ORIGINATION FORM

Proposed Revisions to a Standard Plans Index

Index Number: 443-001

Index Title: French Drain

FRENCH DRAIN ASSEMBLY

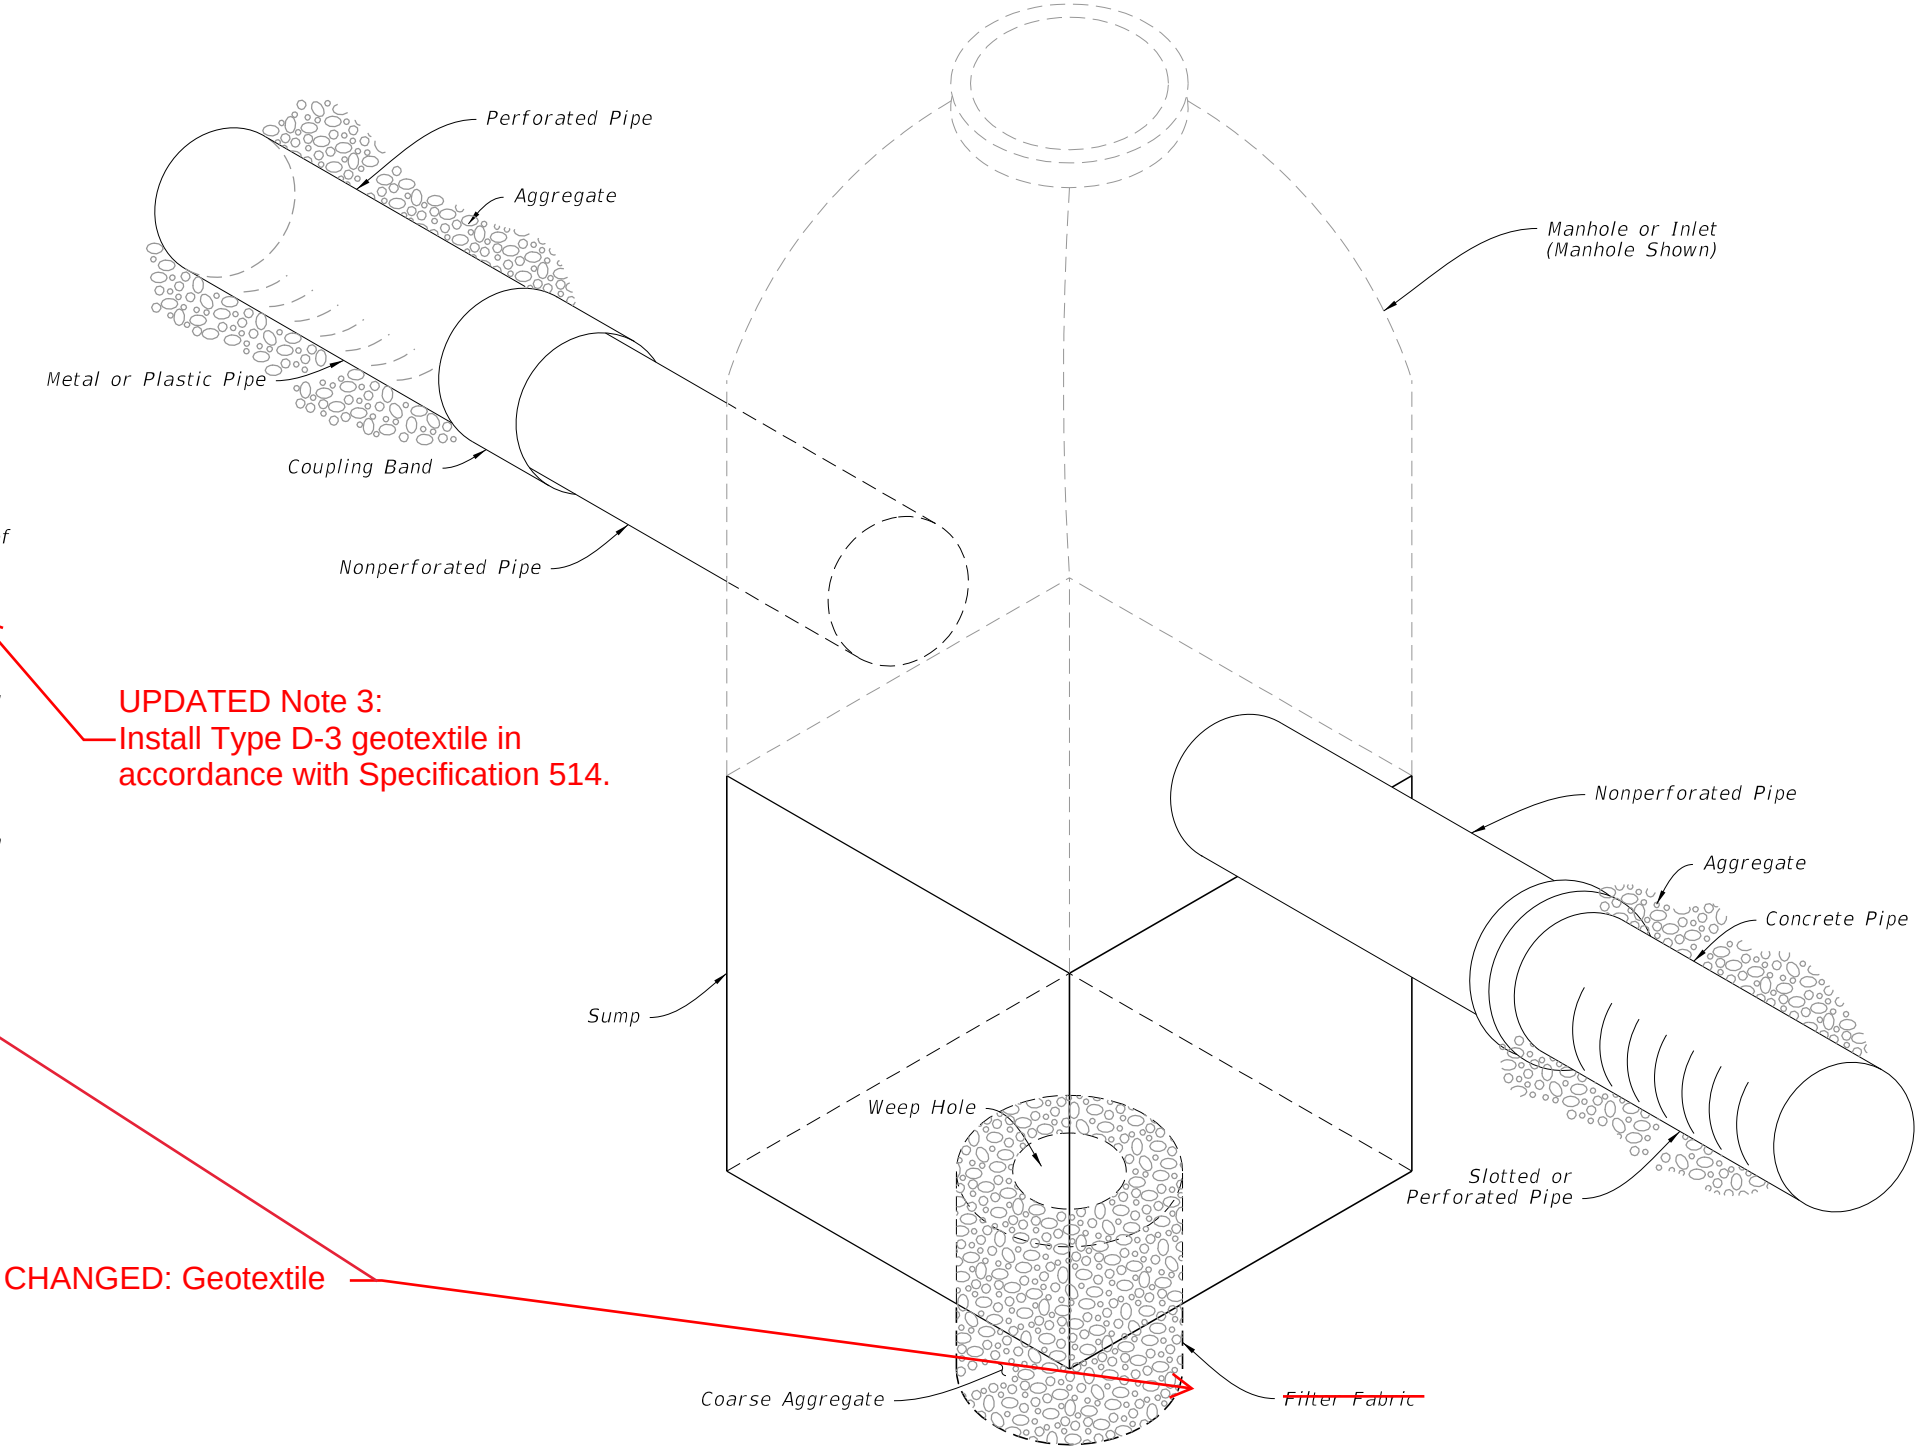
UPDATED Note 3:
Install Type D-3 geotextile in
accordance with Specification 514.

CHANGED: Geotextile

Sheet 1: Updated GENERAL NOTE 3 "Install Type D-3 geotextile in accordance with Specification 514."; Changed all references of "Filter Fabric" to "Geotextile".

FRENCH DRAIN SYSTEM

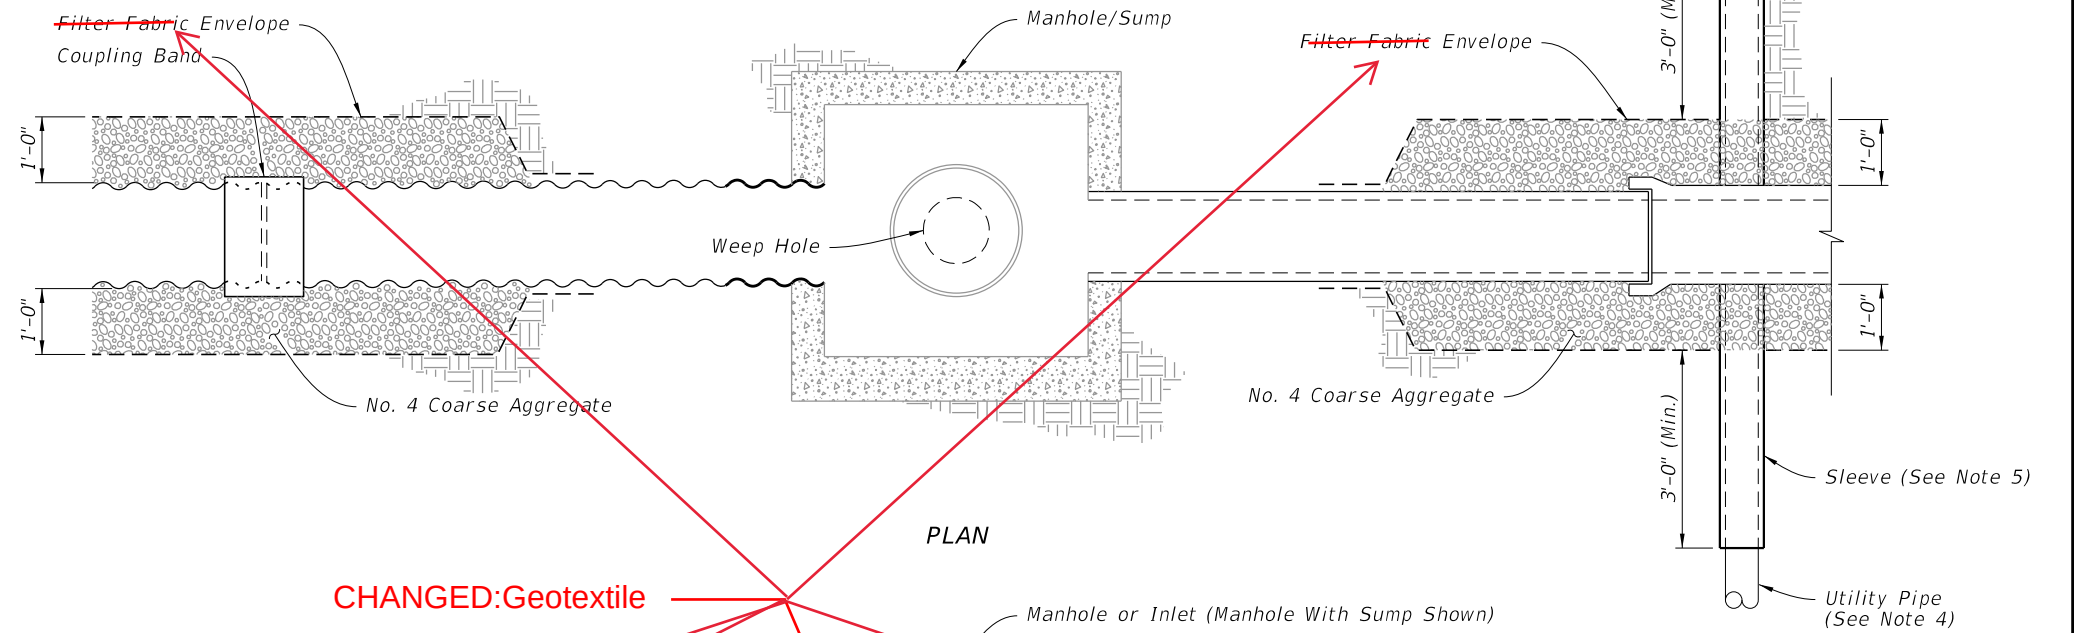
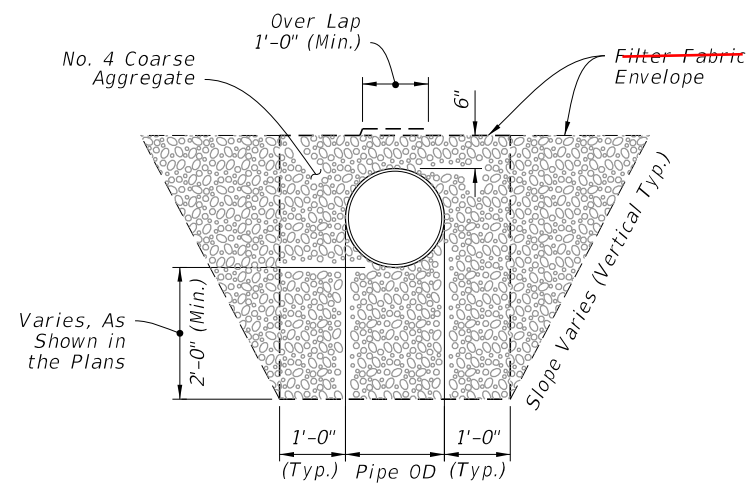
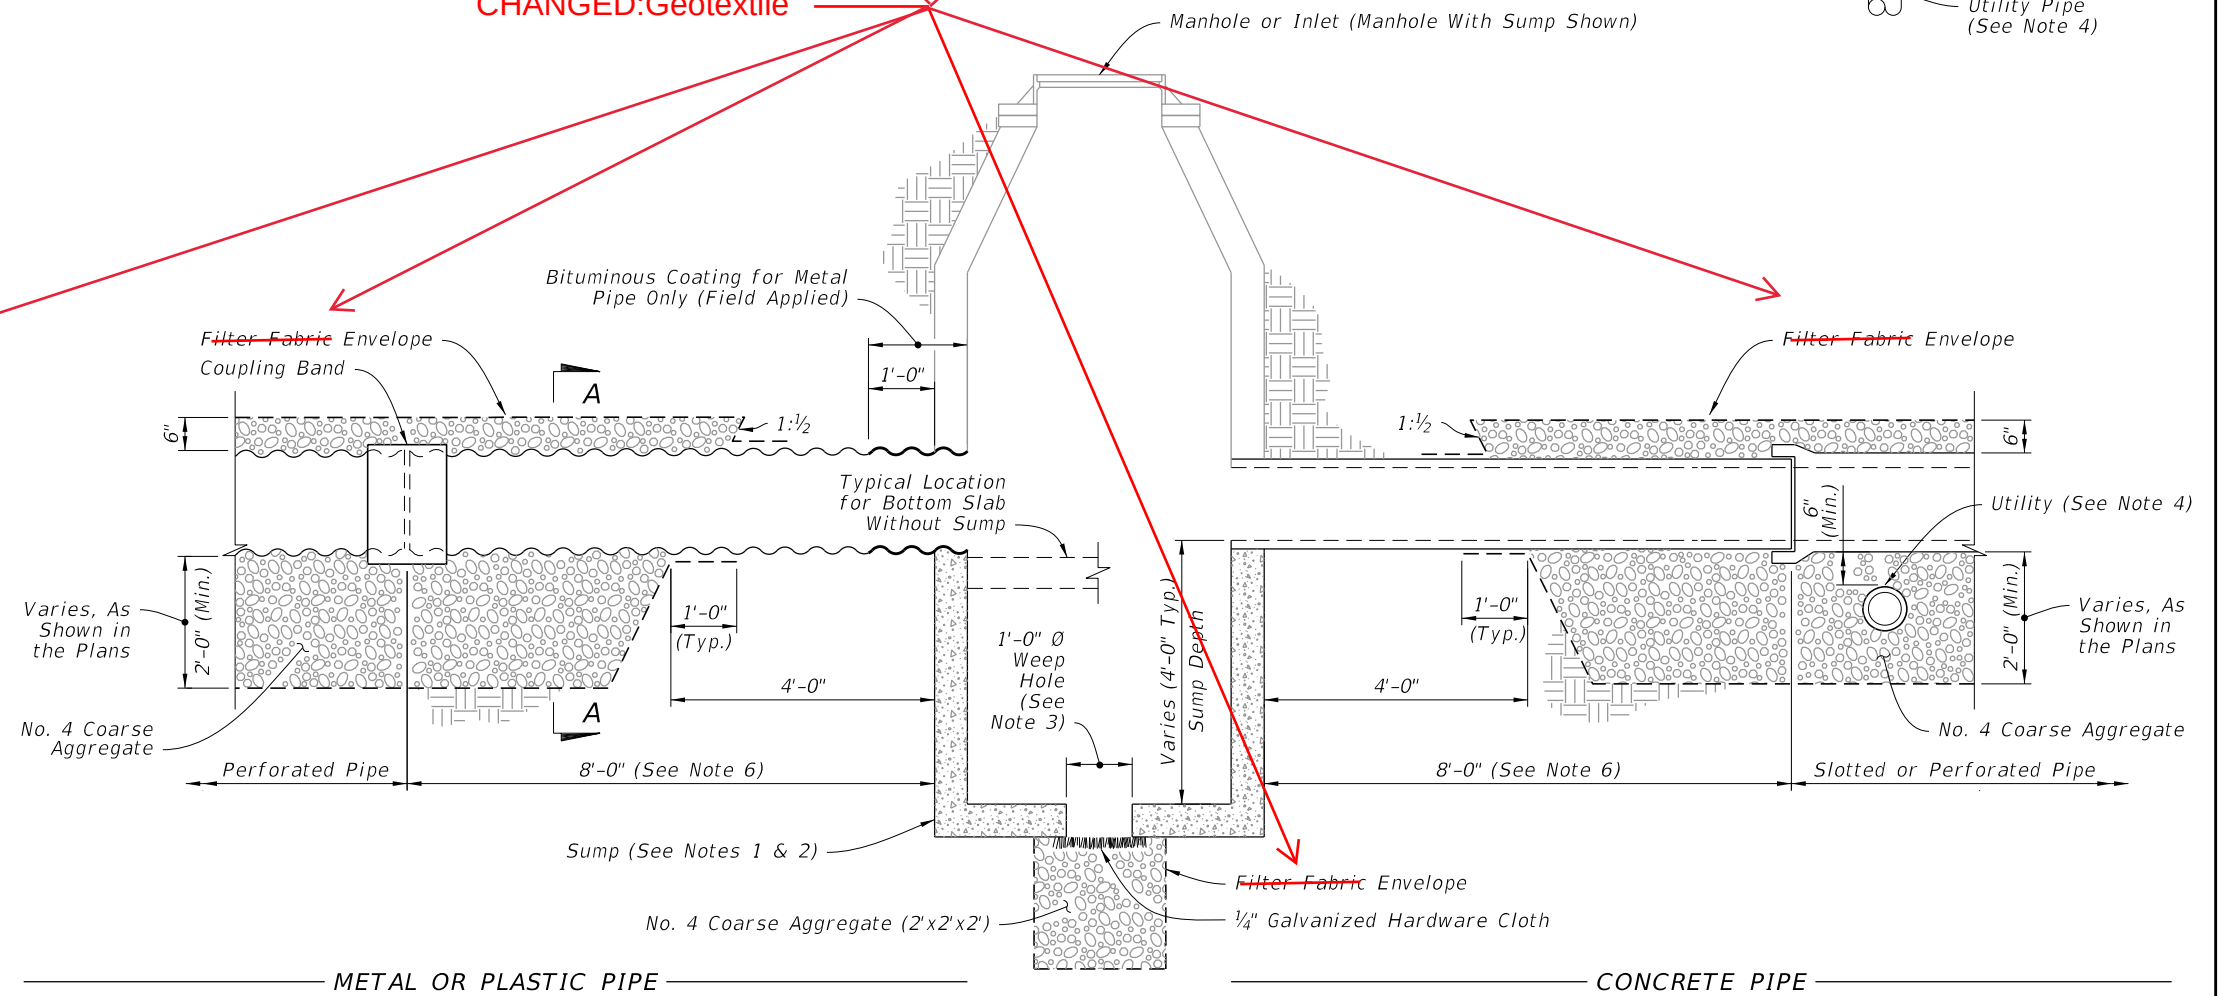
CHANGED: Geotextile

Sheet 2: Changed all references of "Filter Fabric" to "Geotextile".
